UNITED STATES
DEPARTMENT OF THE INTERIOR
BUREAU OF LAND MANAGEMENTOCD Artesia District
NM OIL CONSERVATIONFORM APPROVED
OMB NO. 1004-0135
Expires: July 31, 2010**SUNDRY NOTICES AND REPORTS ON WELLS**
*Do not use this form for proposals to drill or to re-enter an abandoned well. Use form 3160-3 (APD) for such proposals.***SUBMIT IN TRIPLICATE - Other instructions on reverse side.**RECEIVED
JAN 23 2017

Chevron respectfully requests the frac ponds included in this APD will to be expanded.

PROPOSED PADS, POND & ACCESS ROADS
HH SO 10 P3 NO. 15H WELL
SECTIONS 3 & 10, T26S-R27E
EDDY COUNTY, NEW MEXICO

SURFACE USE PLAT

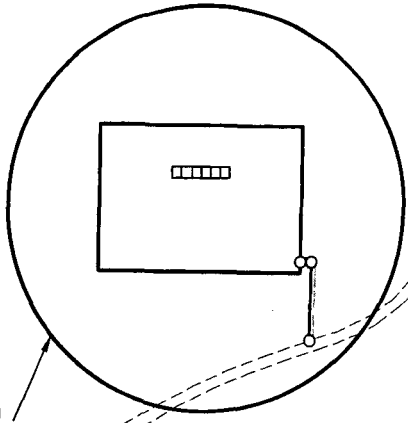
Chevron requests the frac ponds to be expanded from 650' X 650' to 750' X 900' (please refer to the attached plat). An on-site was performed on October 18th by Mr. Paul Murphy, Stan Allison, and Chelsie Dugan, and the location was acceptable to BLM so long as Range approved of a movement of a

fence on the site. Approval was given 11/3 by Steve Daly, subject to written approval by surface tenants. Chevron requests the Frac Ponds to be expanded from 650' X 650' to 750' X 900 (please refer to the attached plat).

Bureau of Land Management
(Proposed Frac Pond- ±13.57 Acres)
(Proposed Frac Pond Outside of
Existing Fence Line- ±0.34 Acres)
(Proposed Fence Line Re-Route-
±109.36', ±6.63 Rods)

Bureau of Land
Management
(Proposed Frac Pond-
±1.93 Acres)
(Proposed Frac Pond
Outside of Existing Fence
Line- ±0.78 Acres)
(Proposed Fence Line
Re-Route- ±628.17',
±38.07 Rods)
